**FORMER MANUFACTURING PLANT
GROUNDWATER TECHNICAL MEMORANDUM**

**FORMER MANUFACTURING PLANT AREA
SHERWIN-WILLIAMS/HILLIARDS CREEK SITE
ADMINISTRATIVE ORDER INDEX NO. II CERCLA-02-99-2035**

March 2014

FIELD CHANGE REQUEST FORM
SHERWIN-WILLIAMS RI/FS
GIBBSBORO, NEW JERSEY

FORMER MANUFACTURING PLANT
PROPOSED MONITORING WELL SAMPLING
DECEMBER 2013

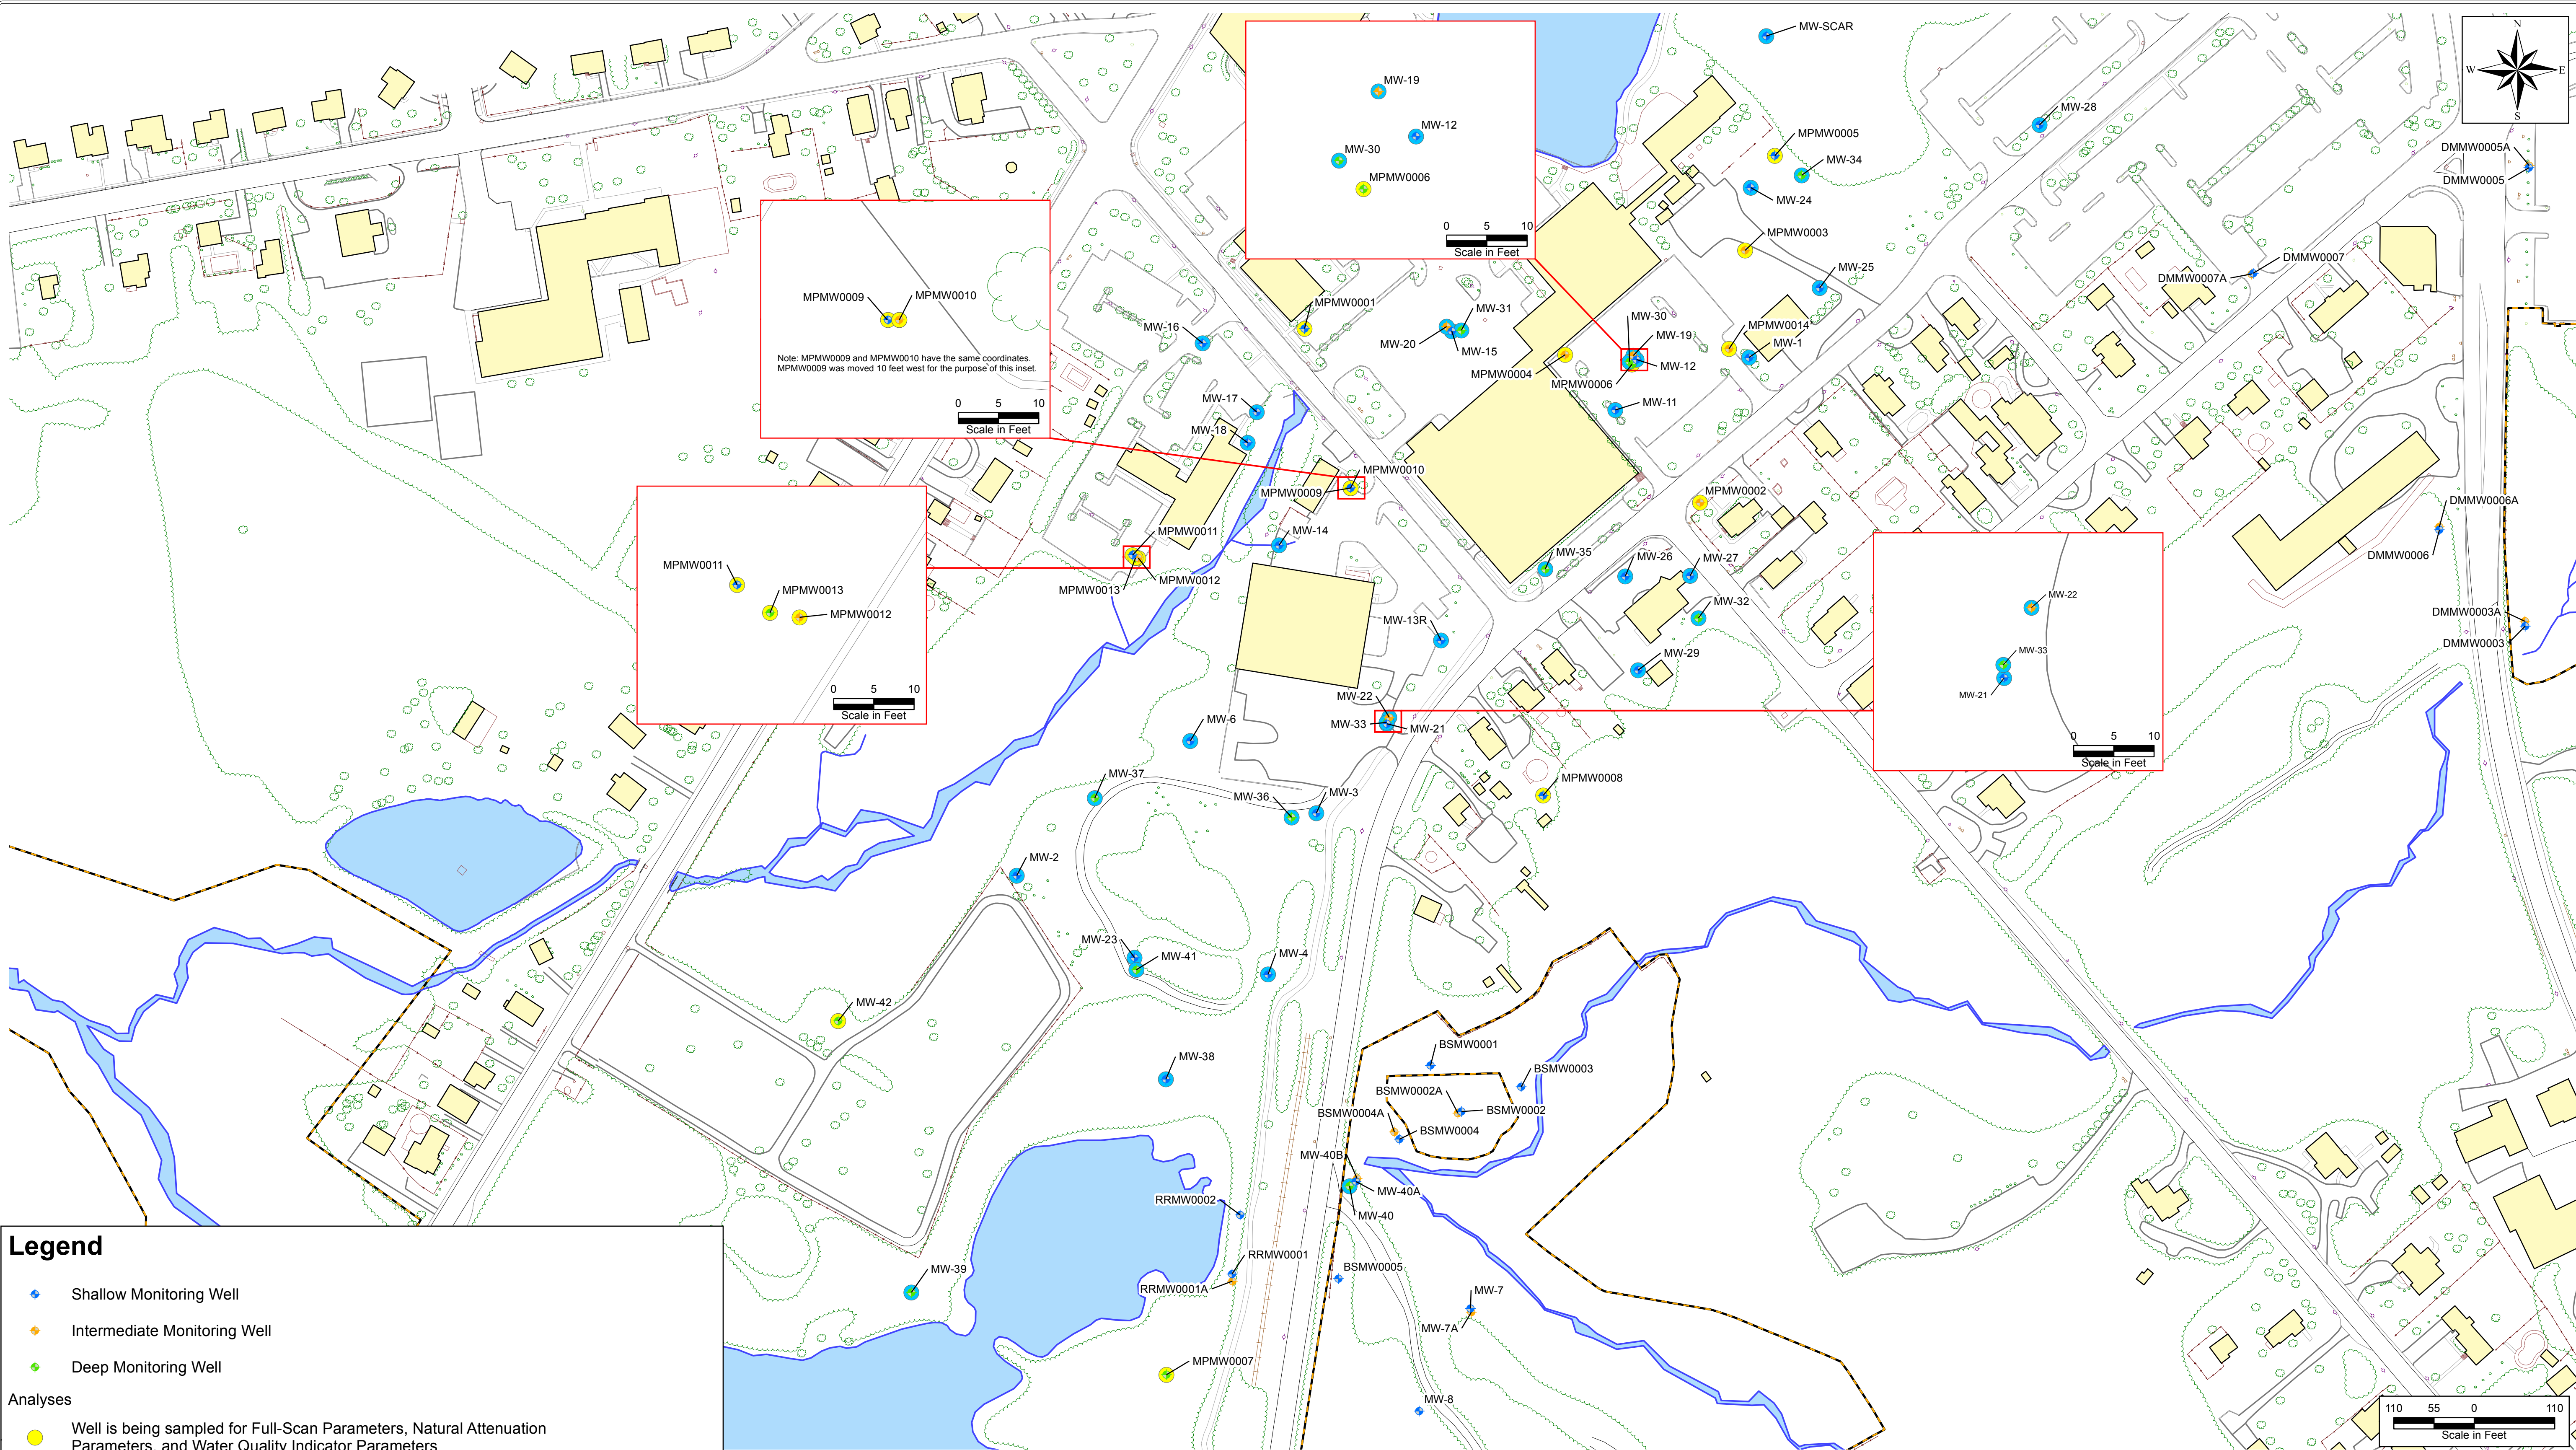
Pre-Remedial Investigation (Pre-RI) monitoring wells (37 wells) have at least two rounds of Full-Scan and natural attenuation parameters under this RI. Sherwin-Williams believes that it is beneficial to complete one concurrent round of groundwater sampling of "ALL" site wells, although EPA is not requesting this activity, they are not opposed to its conductance.

In addition to these monitoring wells, deep monitoring well MW-40 (located in the United States Avenue Burn Site), which was not included for the first or second round in the Updated Revised Work Plan, is also proposed to be sampled. As MW-40 is a deep monitoring well being proposed to confirm the possible extent of groundwater contamination delineation to the east, Sherwin-Williams is proposing to add this well to this round of groundwater sampling for the Reduced Parameters list, TCL VOCs, TCL SVOCs, and TAL metals plus cyanide and WQIPs.

EPA Approval:

Date: 12/9/13
